FINAL DRAFT MINUTES

November 19, 2020 Standards Committee Meeting

RE: Minutes from the November 19, 2020 Standards Committee Meeting

E 609-RCBA-04 REINFORCED CONCRETE BRIDGE APPROACH SECTION, PAVEMENT LEDGE, AND BAR BENDING DETAILS (existing, with shown markups)

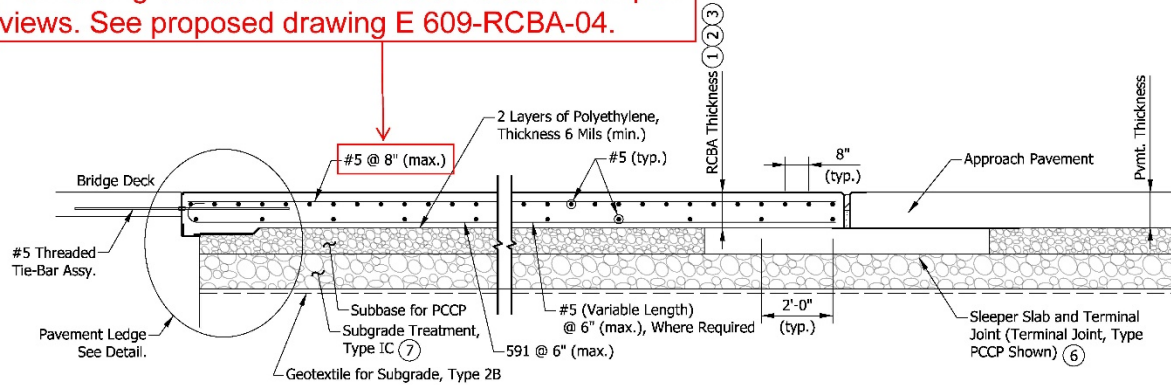
Reinforcing callout revised to be consistent with plan views. See proposed drawing E 609-RCBA-04.

SECTION THROUGH APPROACH

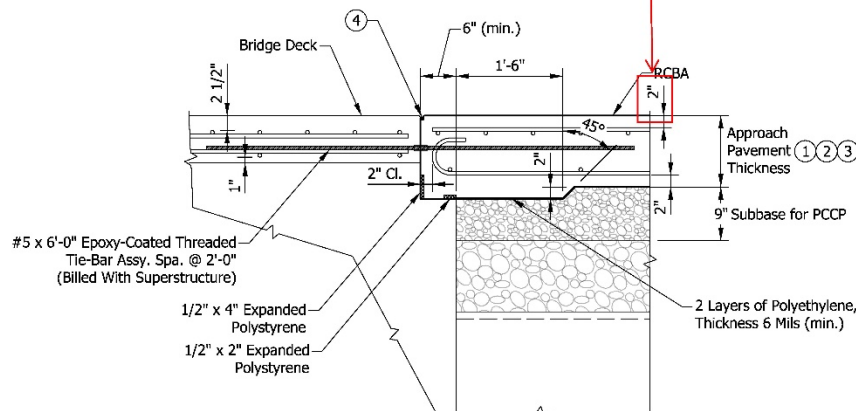
Top clear cover revised to match bridge deck. See proposed drawing E 609-RCBA-04.

E 609-RCBA-04 REINFORCED CONCRETE BRIDGE APPROACH SECTION, PAVEMENT LEDGE, AND BAR BENDING DETAILS (proposed draft)

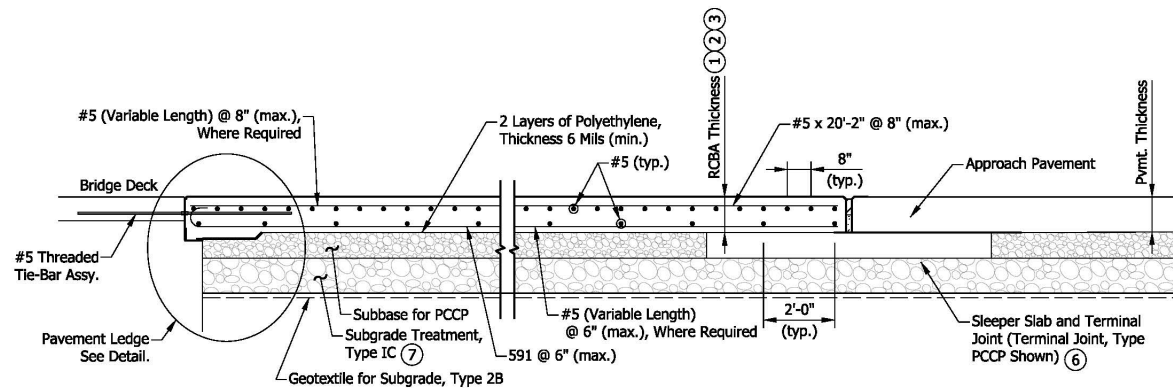
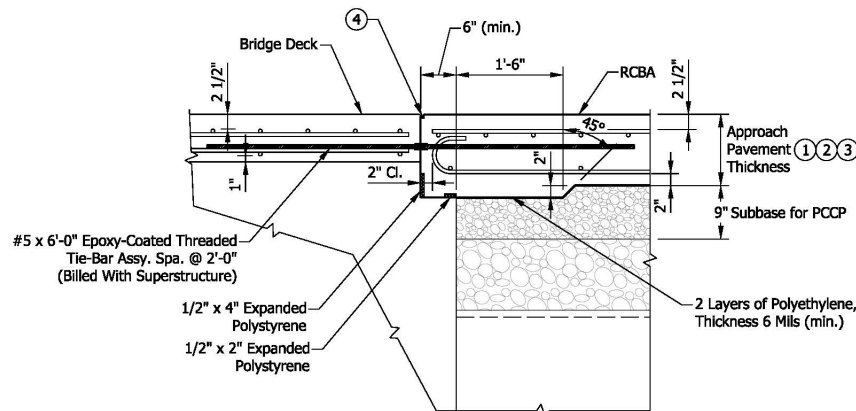
PROPOSED SOLUTION: The TBAE series has been revised to: space the transverse bars with the typical transverse bars in the RCBA, revise the orientation of reinforcing mats to be consistent with the RCBA reinforcing, remove the hooks on the longitudinal bars to reduce congestion, update the width and length of the extensions to be consistent with the current bridge railing transitions, and increase the cover on the top layer of reinforcing to 2 1/2". The RCBA series has been revised to increase the cover on the top layer of reinforcing to 2 1/2", as well as some minor editorial changes.

E 609-TBAE-01 RCBA EXTENSION FOR BRIDGE RAILING TRANSITION TFC, TPF-1, TPF-2, TPS-1, OR TPS-2 (existing, shown markups)

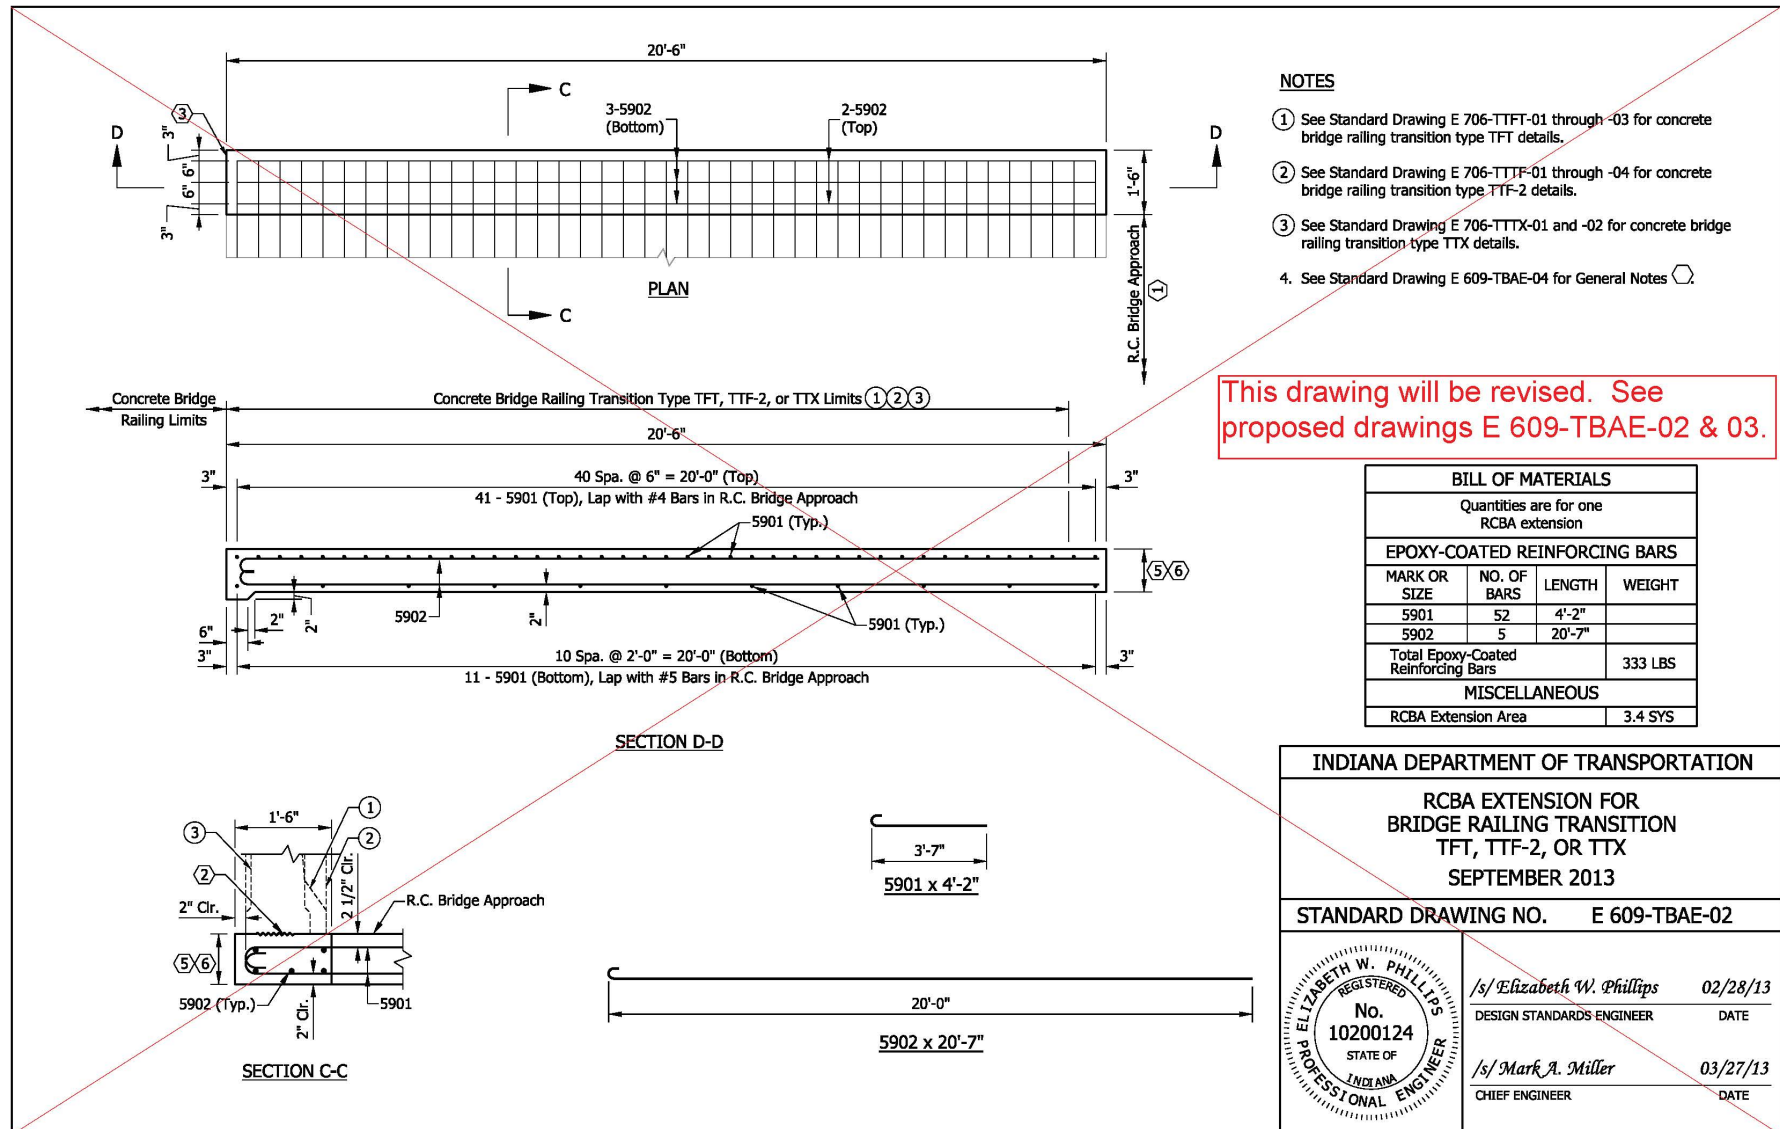
This drawing will be revised. See proposed drawing E 609-TBAE-01.
